Parcel 42 (Hope Point Tower) Concept Plan Summary

I-195 Redevelopment District Commission Meeting
January 18, 2023

Concept Plan Design Review Comments, Waivers, and Amendments

Wind Rose: Jan 01 - March 31, 8am - 8pm

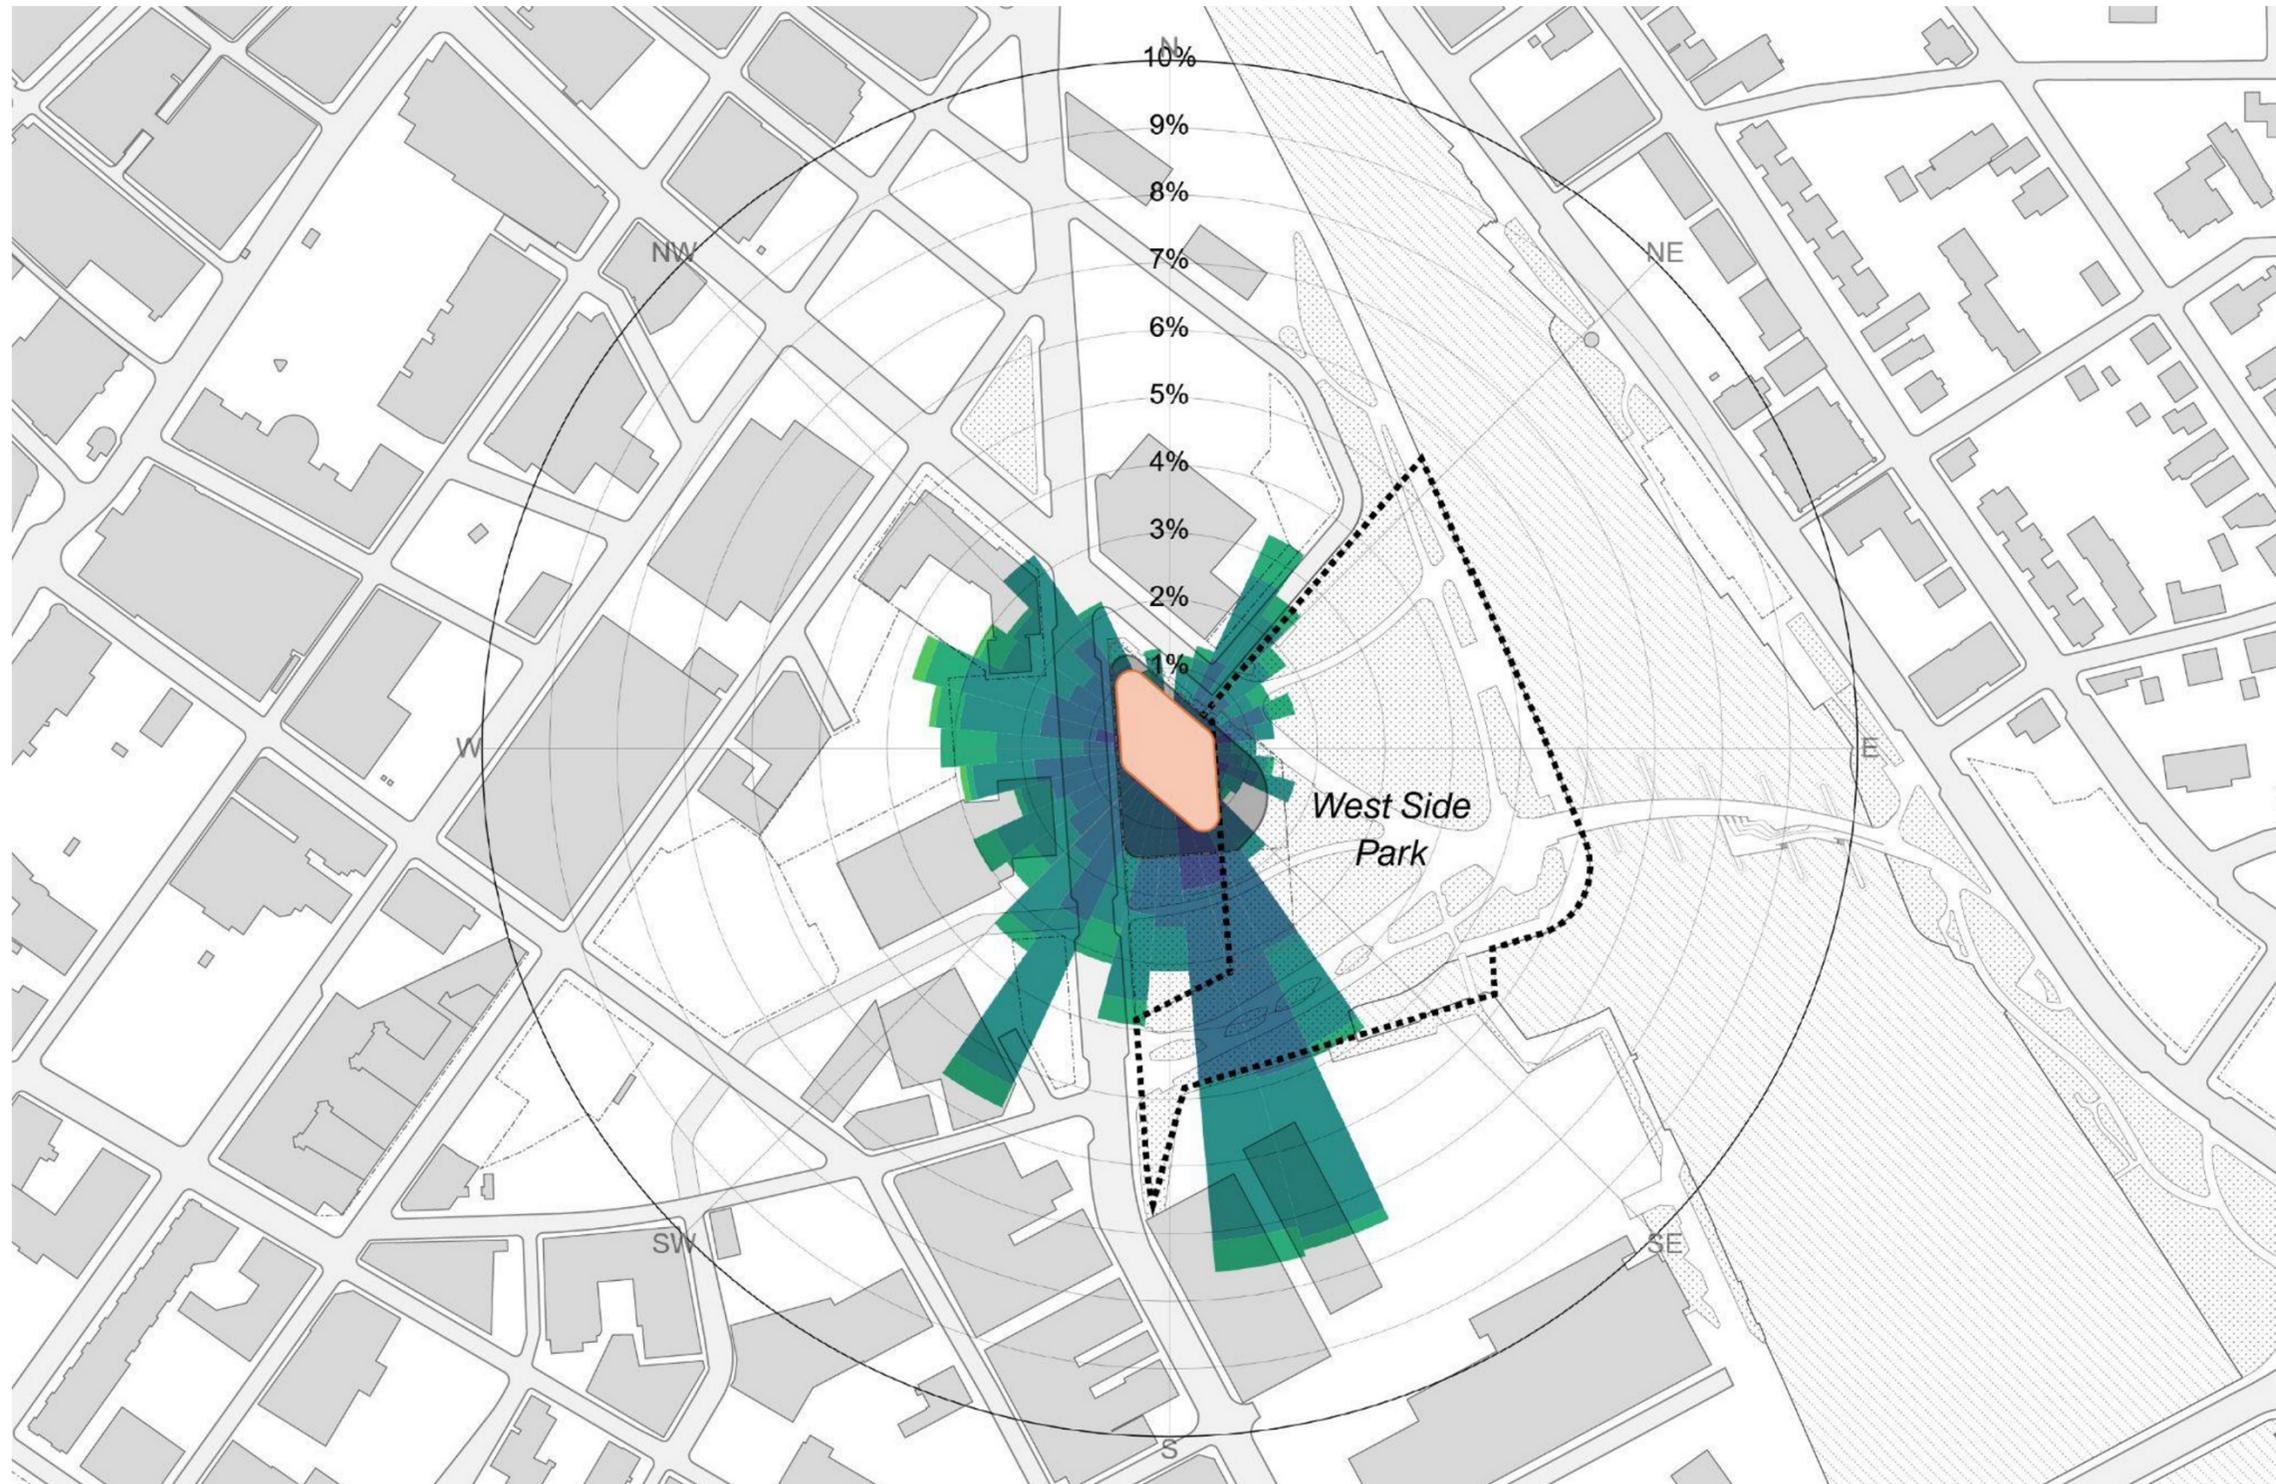
- Prevailing winter winds are primarily from west to north-west orientations.
- Wind speeds are likely accelerated by the surrounding urban context.
- The Fane tower potentially impacts wind turbulence / downdrafts / eddys at the street level.
- There is potential down-wind impact on the West Side Park.
- A CFD study is recommended to fully understand wind impacts.

Wind Rose: April 01 - June 30, 8am - 8pm

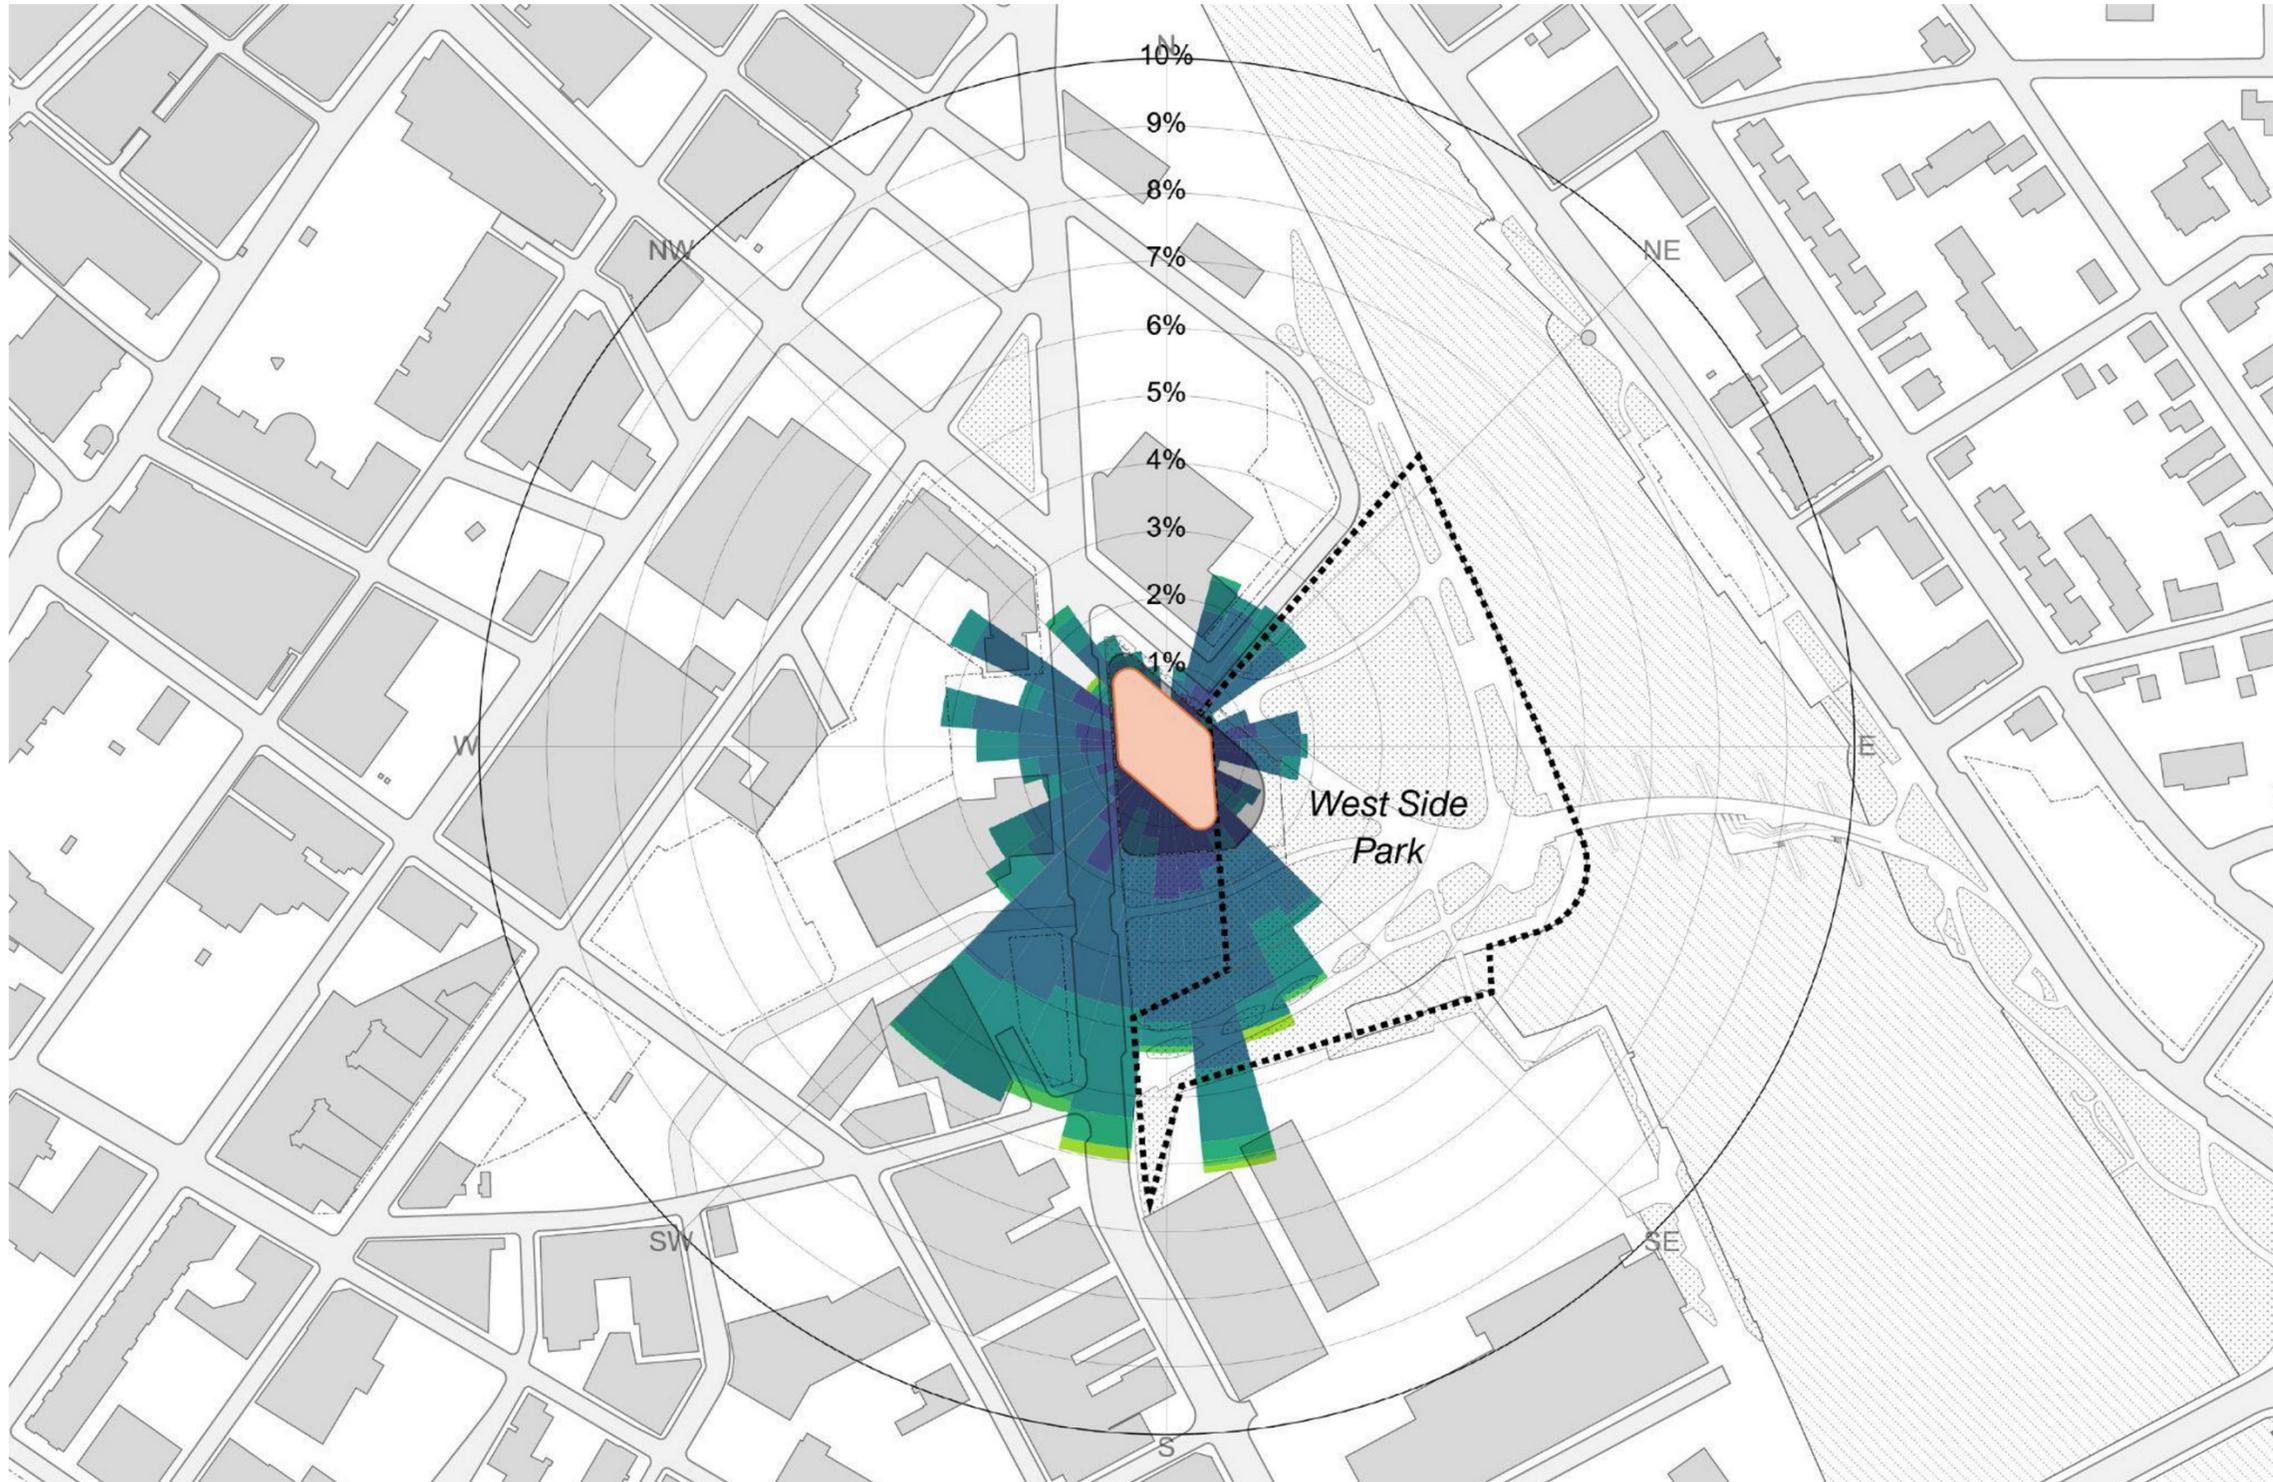
- Prevailing spring winds are primarily from the south.
- Wind speeds are likely accelerated by the surrounding urban context.
- The Fane tower potentially impacts wind turbulence / downdrafts / eddys at the street level.
- There is potential impact on the southern edge of the West Side Park.
- A CFD study is recommended to fully understand wind impacts.
